Subject: Braidwood Station Unit 1
NRC Docket Number: 50-456

Response to Request for Additional Information Pertaining to Operating Interval
Between Eddy Current Inspections for Circumferential Indications in the
Braidwood Unit 1 Steam Generators

ATTACHMENT A
REQUEST FOR ADDITIONAL INFORMATION
RELATED TO THE BRAIDWOOD, UNIT 1 CYCLE LENGTH ASSESSMENT
BASED ON STEAM GENERATOR (SG) TUBE
CIRCUMFERENTIAL INDICATION GROWTH RATES
DOCKET NUMBER 50-456

Figure 14a

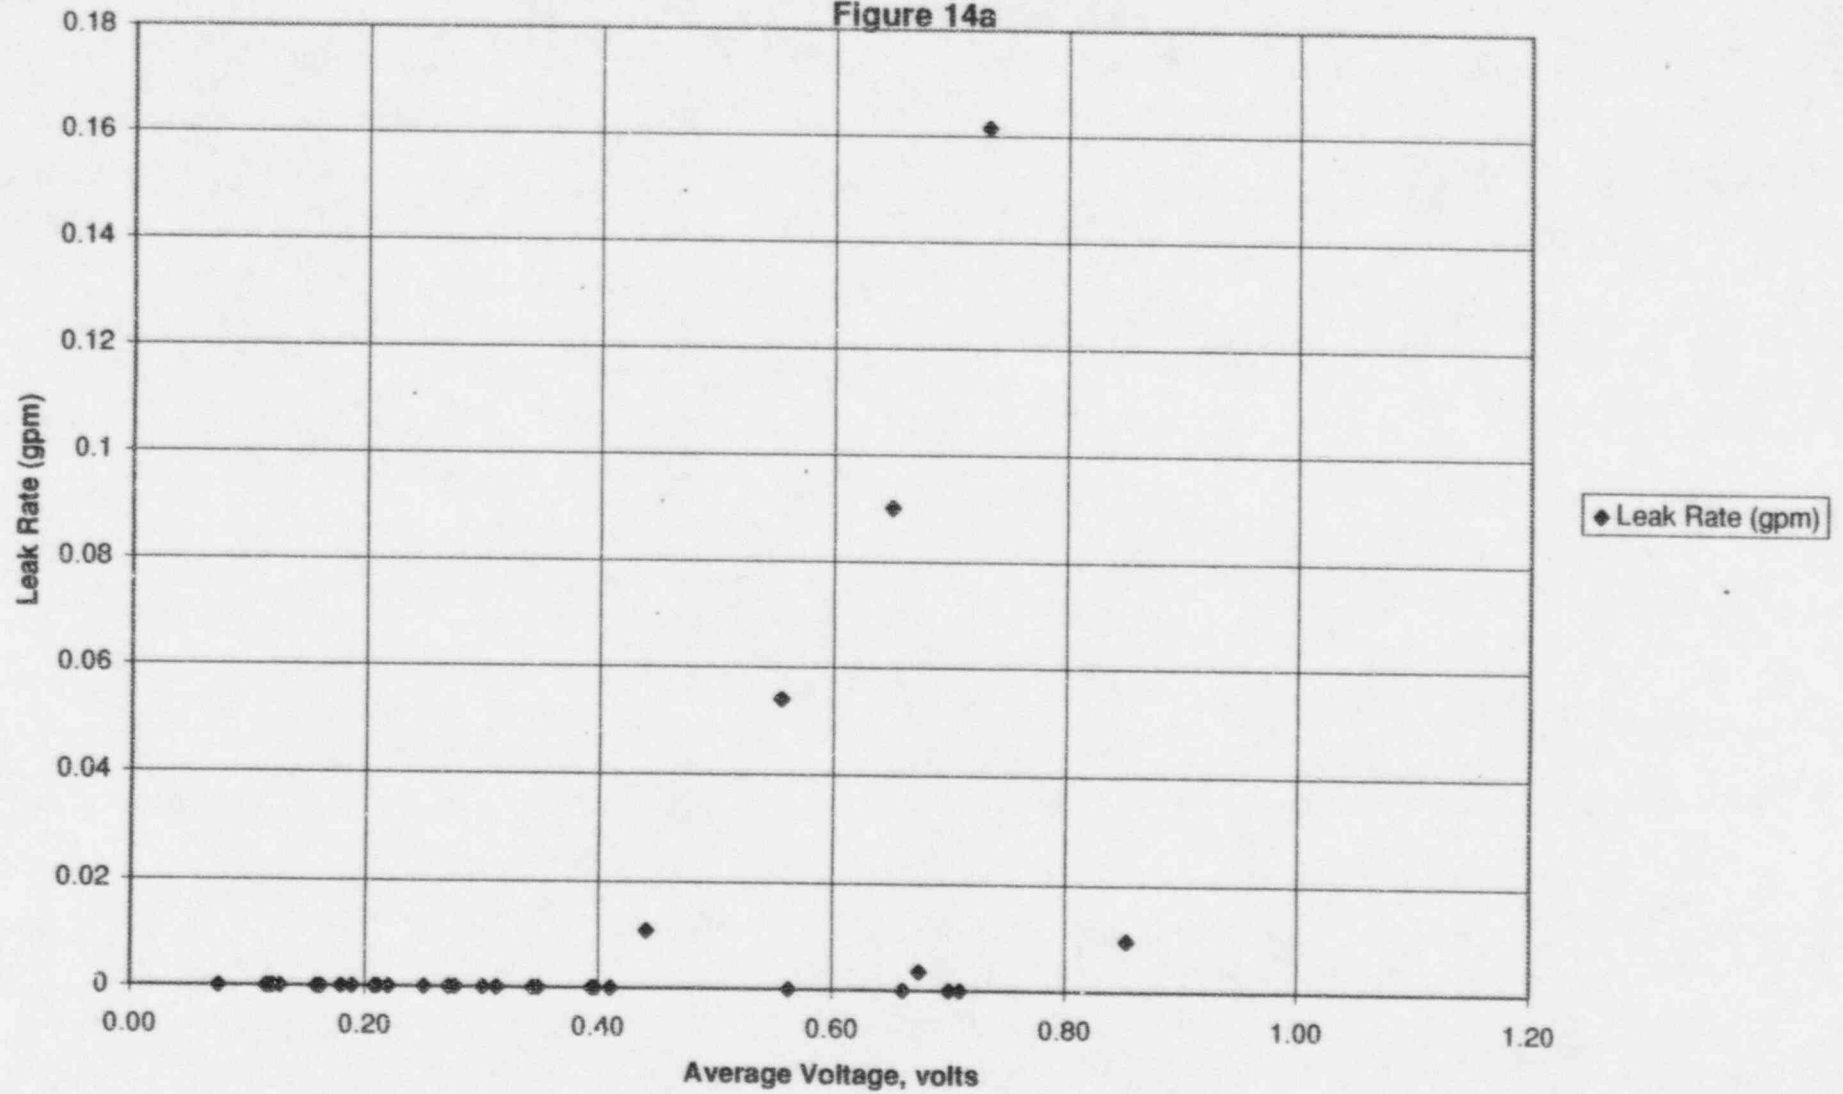
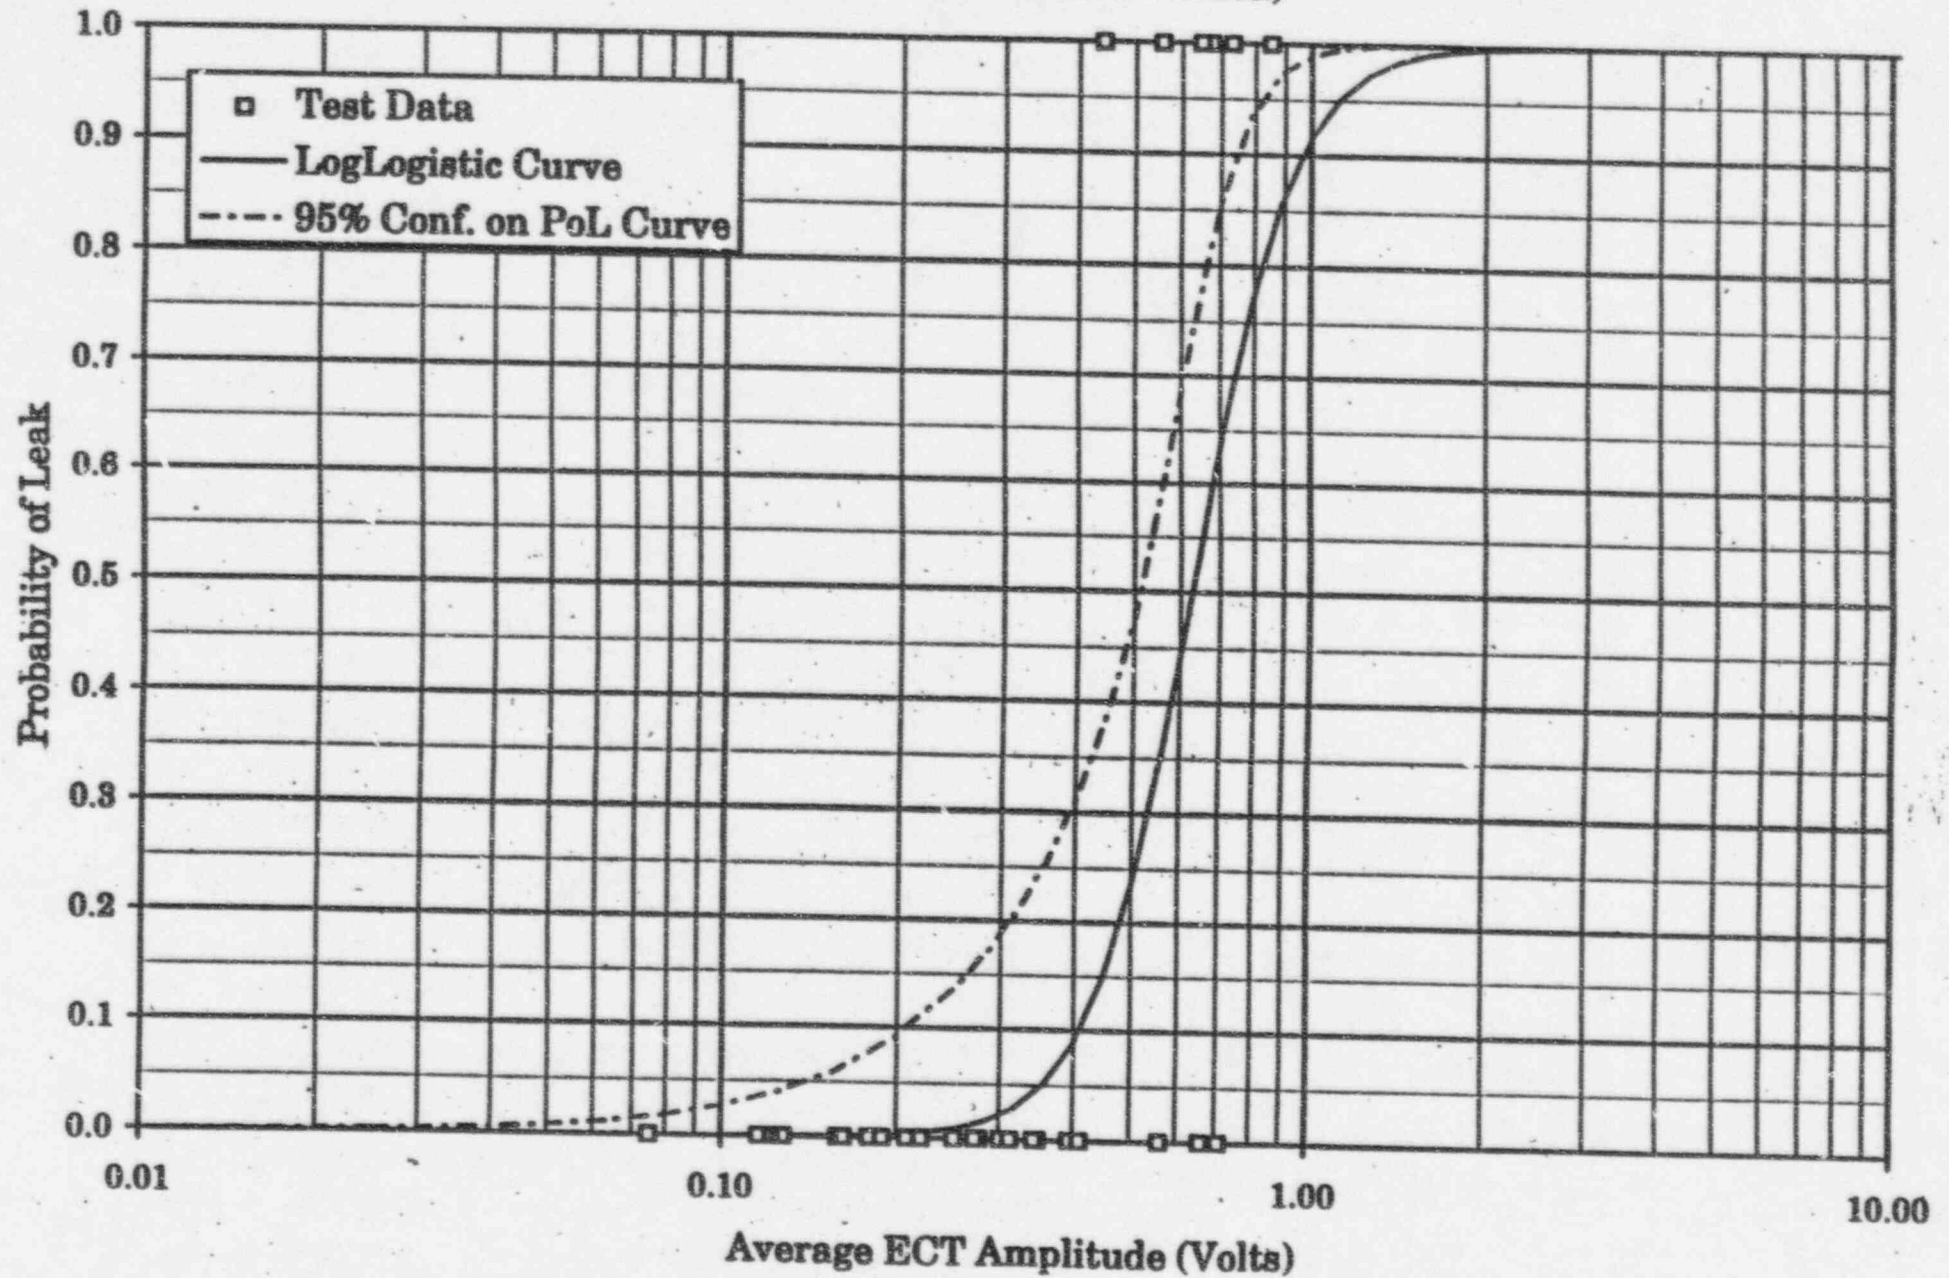
- 14. The correlation of leak rate versus maximum EC voltage applies only to the end-of-cycle (EOC) EC voltage distributions derived from maximum EC voltages. Provide a similar relationship based on EC voltage integral measurements of circumferential indications. Describe, or reference if previously submitted, the procedure used to normalize the SG tube leak rates to the operating temperature and the main steam line break (MSLB) pressure of 2560 pounds per square inch (psi).**

The industry leak rate data from insitu pressure tests and tube pull leak tests is provided in the response to Question 5 and is plotted in Figure 14a against average voltage. The average voltage is normalized as discussed in Section 6.2.1 of the Braidwood Cycle Length Assessment Report dated August 2, 1996. A log-logistic probability of leak vs. average ECT amplitude function was developed. The probability of leak function is based upon the data presented in Section 7.0 of the Braidwood Cycle Length Assessment Report dated August 2, 1996. A 95% confidence level of the probability of leak function is used to assess the Braidwood Unit 1 EOC leak rate for the EOC approach for average voltage. Figure 14b shows the function and its lower 95% confidence level. Because a correlation between voltage and leak rate does not exist a maximum leak rate of 0.16 gpm is assumed for each voltage bin.

Figure 16: Probability of Leak vs. Maximum ECT Amplitude
(Commonwealth Edison Data)

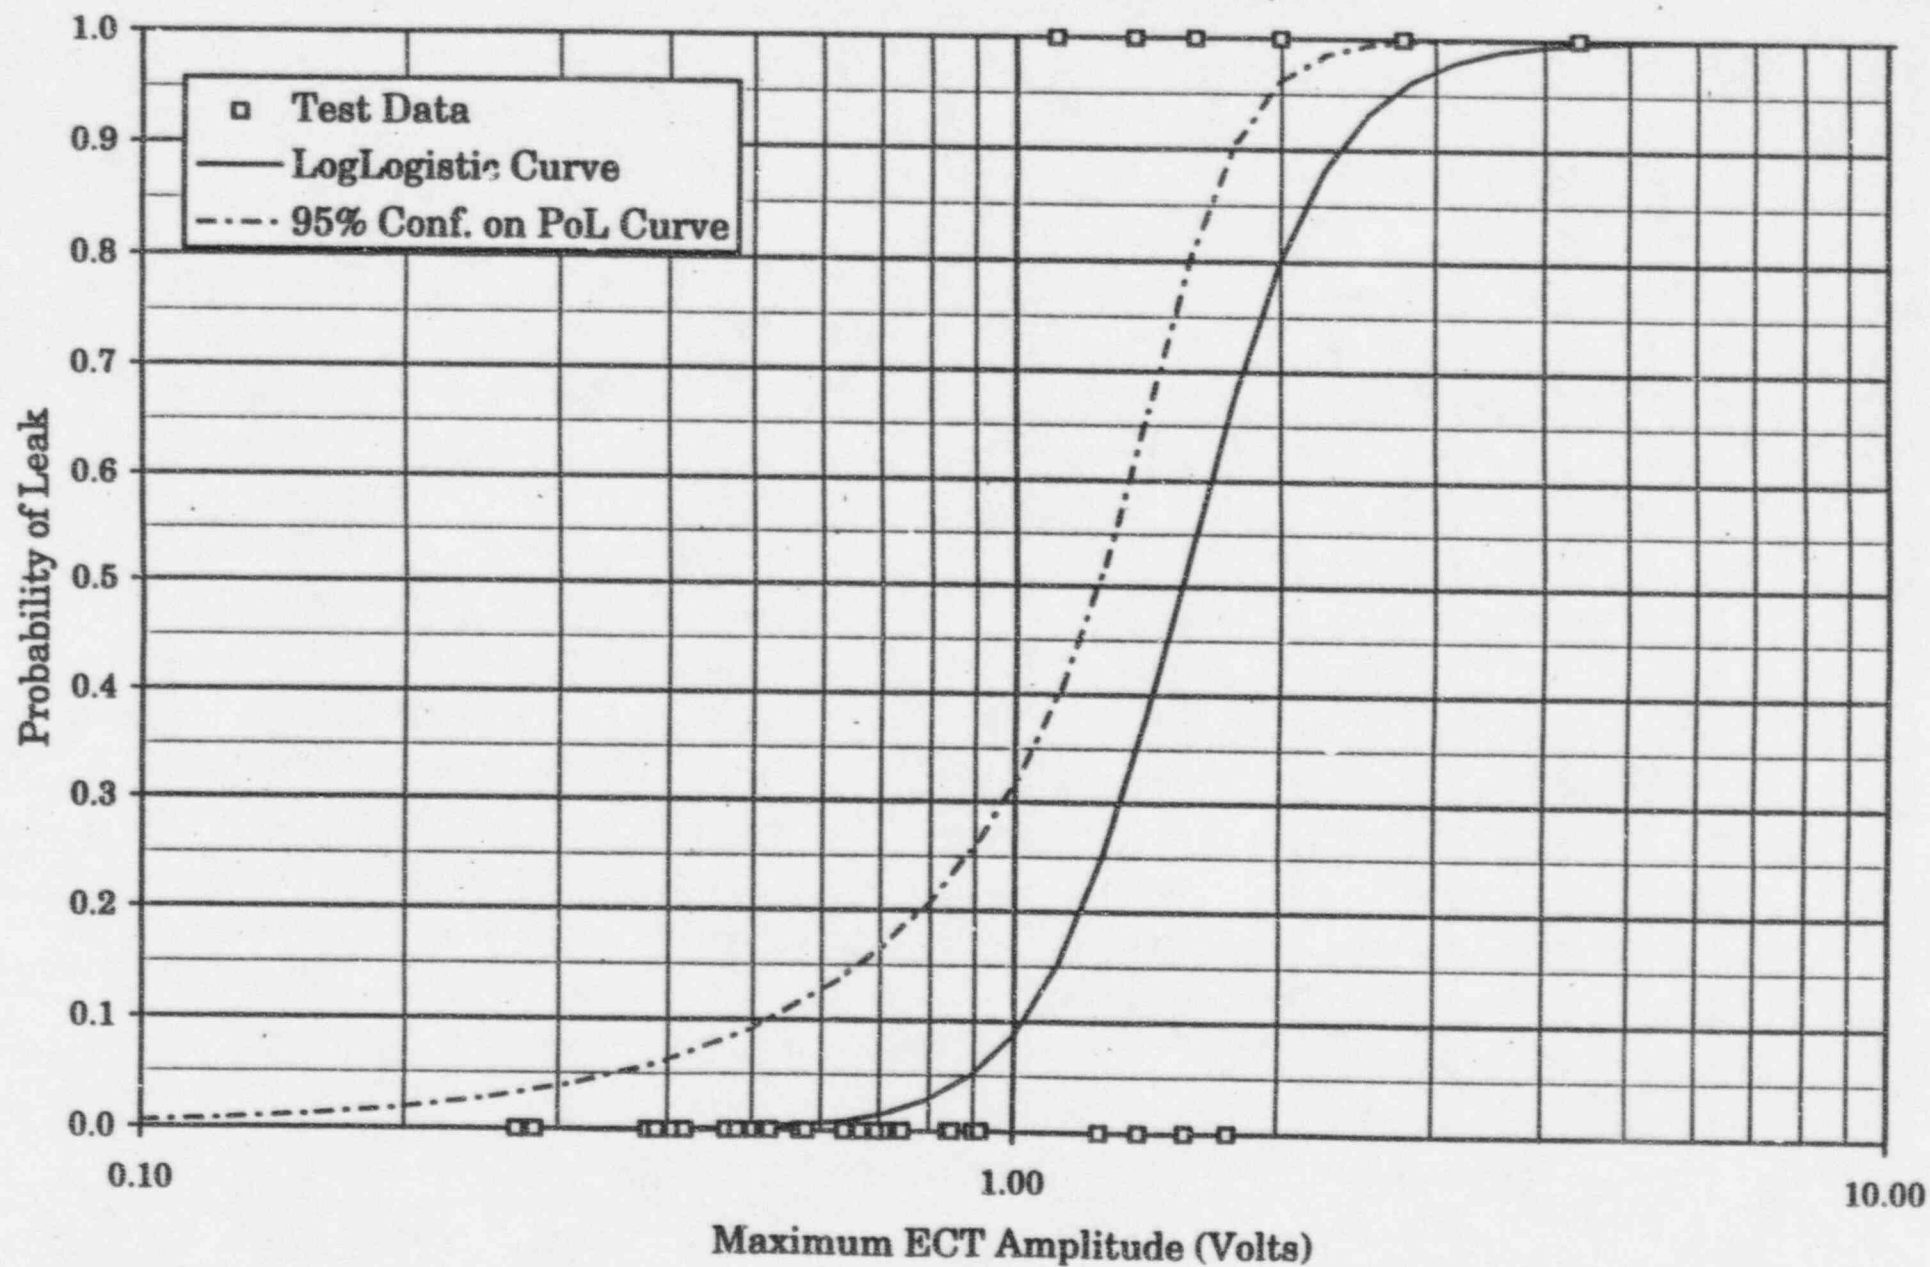
- 16. Given that for any EC voltage, a variety of morphologies can exist as discussed in Items 1 and 9 above, discuss the basis for assuming that there is an EC voltage cutoff for determining when a SG tube is susceptible to leaking. Discuss how the proposed methodology would account for the uncertainty in the potential for a SG tube to leak and the uncertainty in the leak rate itself. Further, given the limited amount of SG tube leakage data for circumferential indications, discuss why the bounding value of SG tube leakage which is assumed, is conservative.**

In order to provide additional conservatism in the leak rate analysis, to address limited data and uncertainties in the industry leak rate data, a log-logistic probability of leak vs. Maximum ECT amplitude function was developed. The probability of leak function is based upon the data presented in Section 7.0 of the Braidwood Cycle Length Assessment Report dated August 2, 1996. A 95% confidence level of the probability of leak function is used to assess the Braidwood Unit 1 EOC leak rate for the EOC approach. Figure 16 shows the function and its lower 95% confidence level. Because a correlation between voltage and leak rate does not exist a maximum leak rate of 0.16 gpm is assumed for each voltage bin. Operating experience has demonstrated that circumferential cracks, even those with significant degradation, do not leak significantly under normal operating conditions. This is most likely due to the presence of ligaments observed from tube pull metallographic results. The leakage assumed in the analysis is the largest leakage (corrected to Braidwood MSLB conditions) measured during tube pull or insitu pressure leak testing and provides more realistic results than the calculation approaches. The 0.16 gpm leak rate is applied to all voltage bins where leakage has been identified to occur. This conservatively applies the highest observed leak rate, corrected to MSLB conditions, to a distribution of indications which have been observed through testing to have significantly lower leak rates.

The EOC-6 leak rate will be calculated by summing the leak rate at each bin which is calculated as follows: obtain the product of the number of tubes in each bin and the probability of leak of tubes at the bin voltage then multiply by the bounding leak rate (from tube pull leak rate testing and insitu pressure testing).
